Remarks

Amendments to the Drawings:

Application Serial No. 10/711,331
Annotated Sheet Showing Changes

Fig. 1
(PRIOR ART)

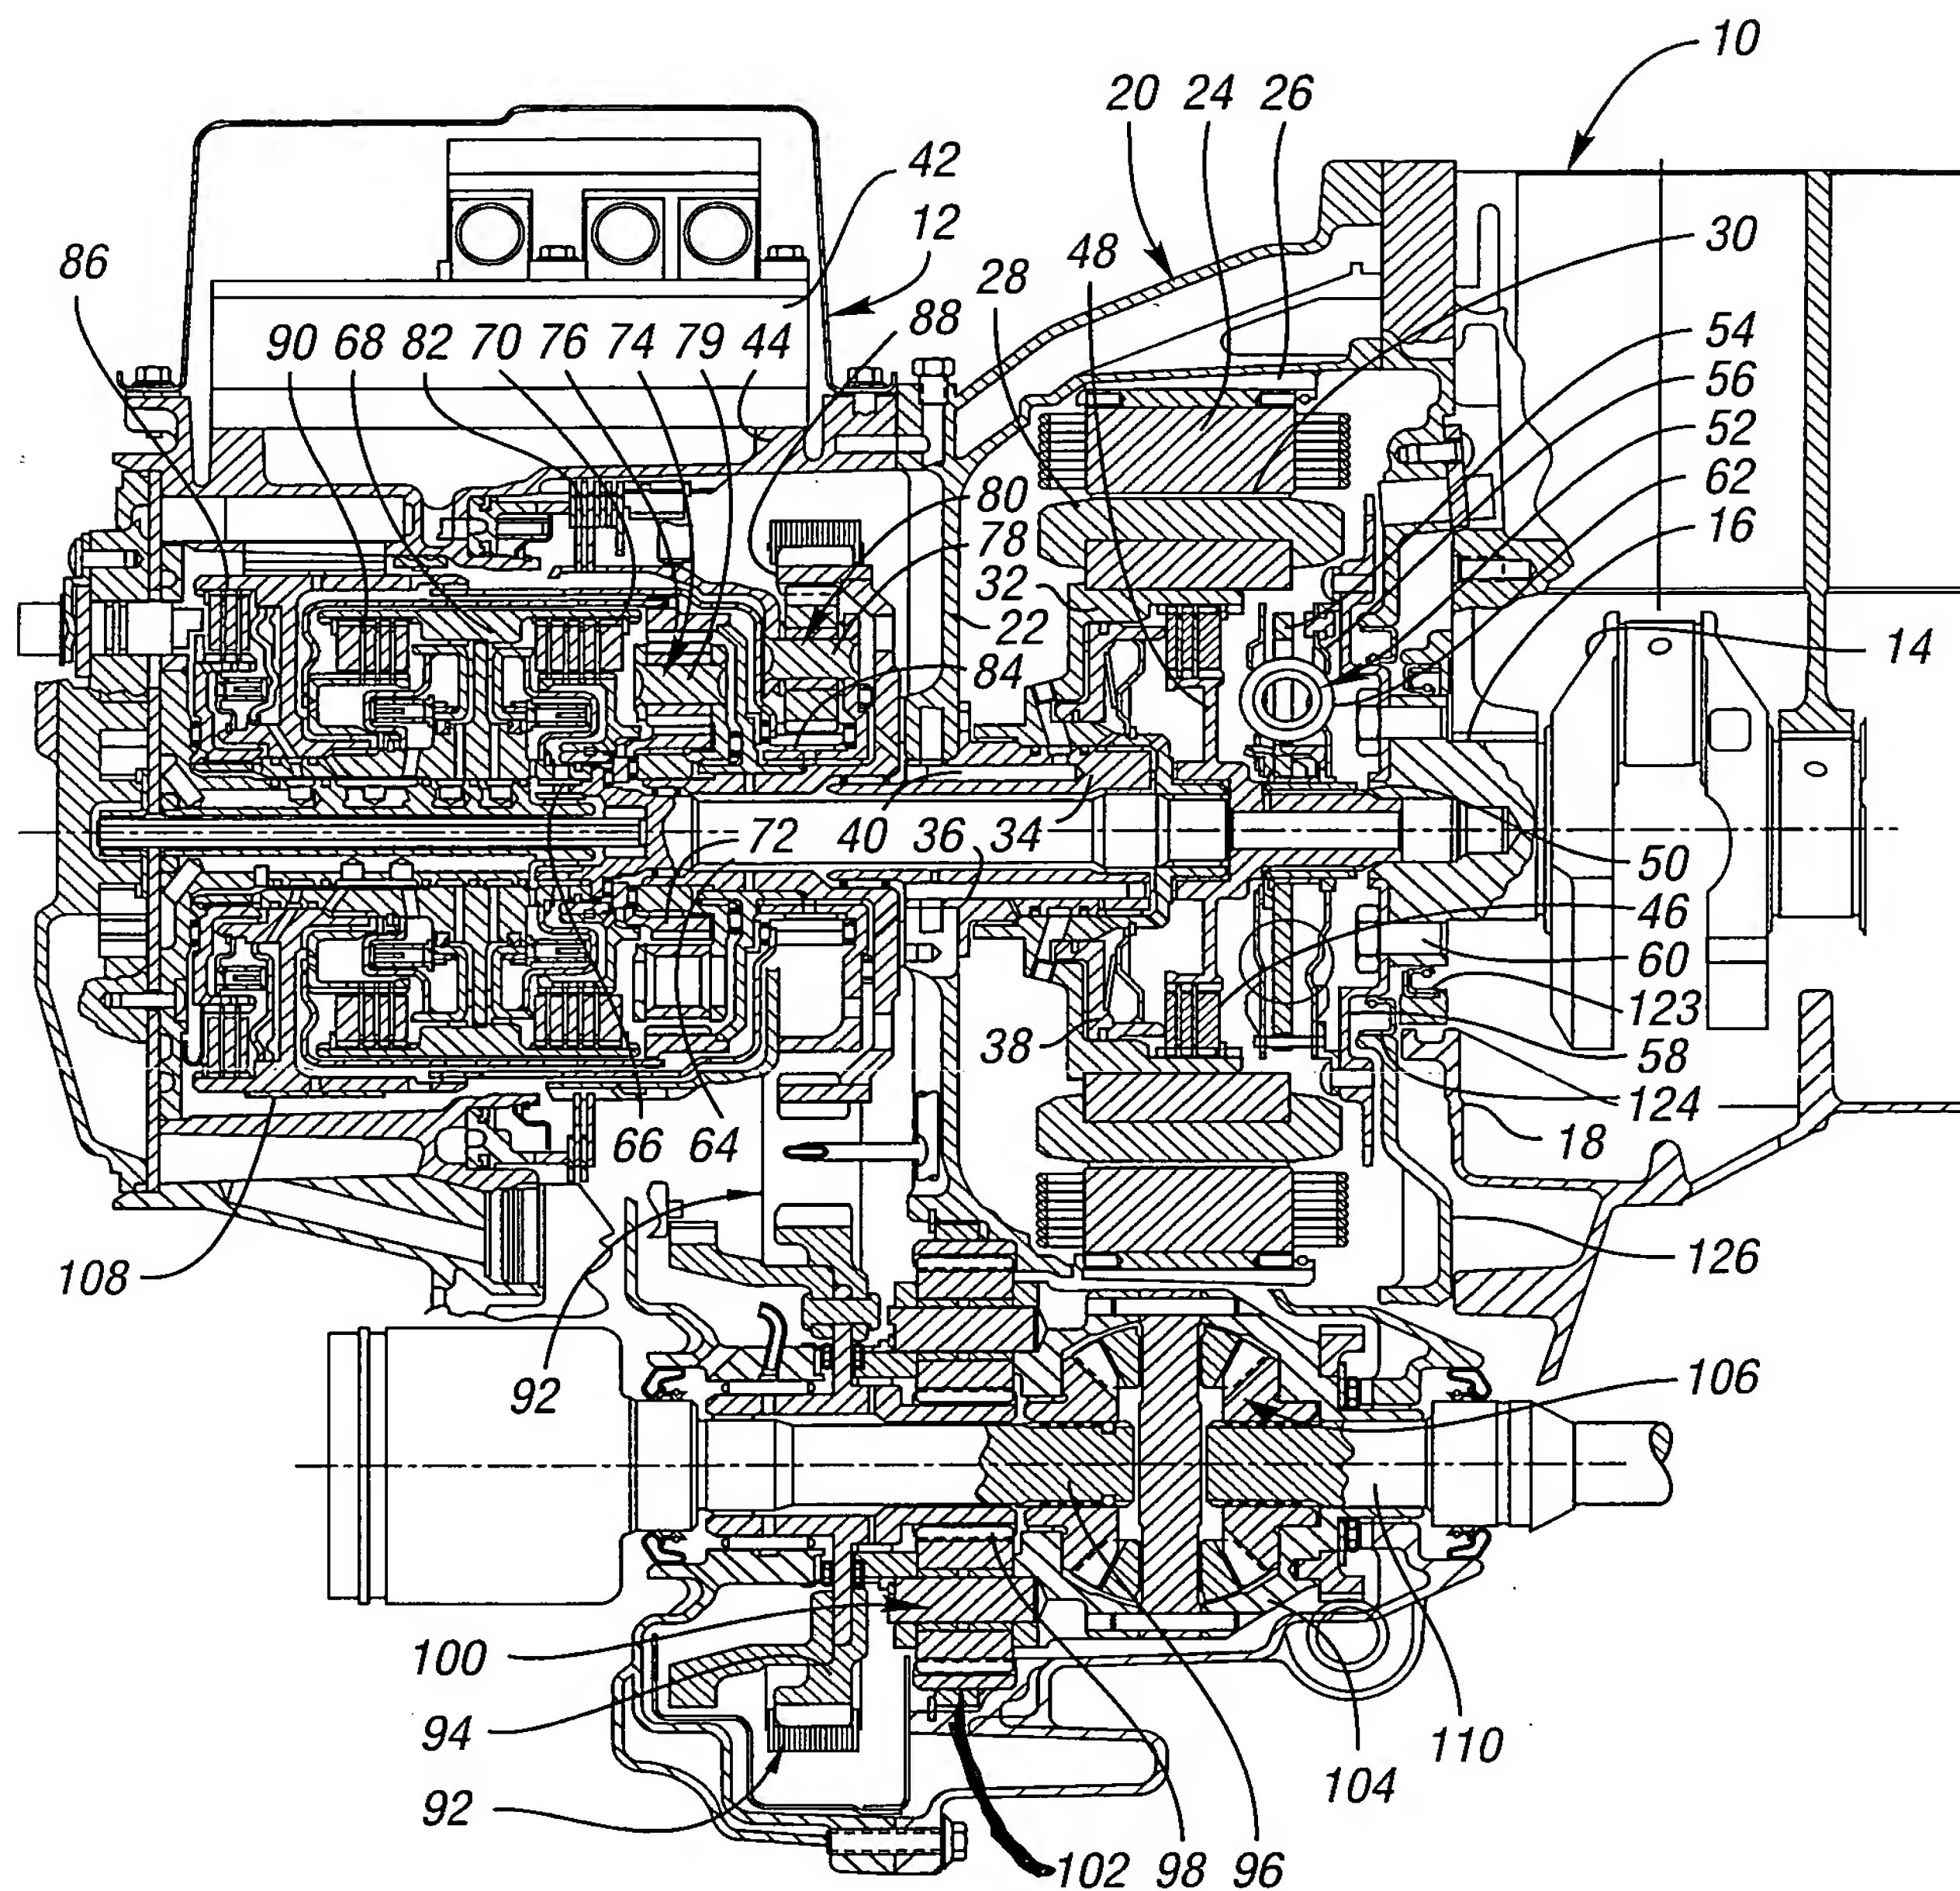
Figures 1, 7a and 7c are amended as shown by red check marks on the attached marked-up copy of these figures. The change to Figure 1 makes the lead line or numeral 102 shorter. The change to Figure 7a relocates numeral 182 so that it identifies a short initialization time. The change to Figure 7c extends the arrowhead for the lead line for the measured 2-4 pressure so that it touches plot 202.
